# Rezoning Transportation Analysis

Petition Number: 2019-028

## Revision Log:

Date	Description
03-20-19	First Review

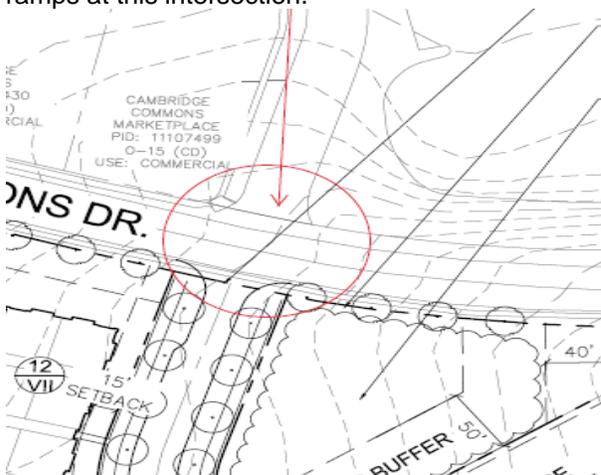
- The petitioner should revise the site plan and conditional note(s) to commit to installing a pedestrian refuge on Cambridge Commons Drive to connect to shopping center in the general area shown below.

- The petitioner should revise the site plan and conditional note(s) to commit to installing and improving ramps at this intersection.
